**CONOCO SERVICE STATION SOIL CONTAMINATION  
REVIEW OF RISK ASSESSMENTS FOR GROUNDWATER  
AND SOIL TREATMENT SYSTEMS  
SACRAMENTO, SACRAMENTO COUNTY, CALIFORNIA**

**APRIL 24, 1997**

**HEALTH CONSULTATION**

**Prepared by  
California Department of Health Services  
Under Cooperative Agreement with the  
Agency for Toxic Substance and Disease Registry**

**FIGURE 1**

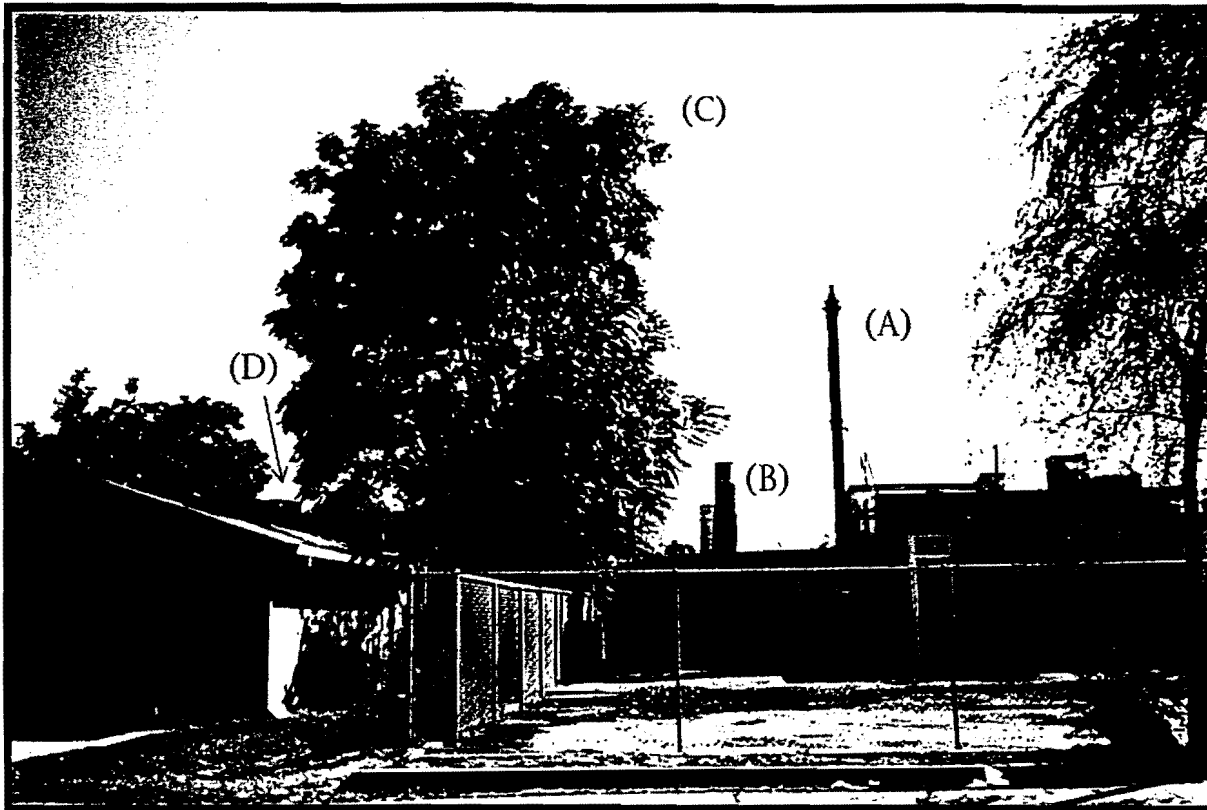
observations focused mainly on the physical location of the two units with regard to the neighborhood. Observations included (Figure 1):

- 1) Close proximity of air emission units to nearest receptor (former residence of petitioner) ( 20 feet).
- 2) Heating / air conditioning unit on roof of nearest receptor.
  - a. Air intake on unit directly downwind of stacks.
  - b. Air intake potential elevated receptor.
- 3) Tall tree (>50 feet) located between the two units and the nearest receptor.
- 4) Service station building directly upwind and other structures surrounding the stacks.

Downwash caused by physical structures near the thermal oxidizer such as a very tall tree, service station building, the air stripper, and the nearby residence may cause a building wake effect, where higher concentrations will occur closer to the source (9). The Code of Federal Regulations [CFR51.100 (jj)(1)] states sources located within five building lengths of a structure are considered close enough to be of concern in determining downwash potential. The stack height (16 feet 3 inches) of the thermal oxidizer was not adequate to allow the plume to escape the wake of the building (9). EPA states the "Good Engineering Practice" equation  $H_b + 1.5L$  ( $H_b$  = structure height,  $L$  = lesser of structure height or width, m) should be used in the determination of stack heights (9). According to CDHS files, downwash and wake effects were not taken into account in the permitting of this unit (5,8). In June 1992, SMAQMD performed additional modeling in an attempt to address building downwash for the tall tree adjacent to the stack (8). CDHS has reviewed SMAQMD model account for downwash, and due to the fact that there are multiple structures which may influence plume behavior, it seems the model does not have the capability to adequately assess downwash occurring at the site.

SCREEN and PTPLU model calculations are based on a simple flat terrain parameter. The specific characteristics at this site such as the tall tree, air stripping tower, and the heating / air conditioning unit intake on top of petitioners residence, appear to be more conducive of a complex terrain situation. Complex terrain is defined as terrain exceeding the height of the stack being modeled (9). The United States Environmental Protection Agency
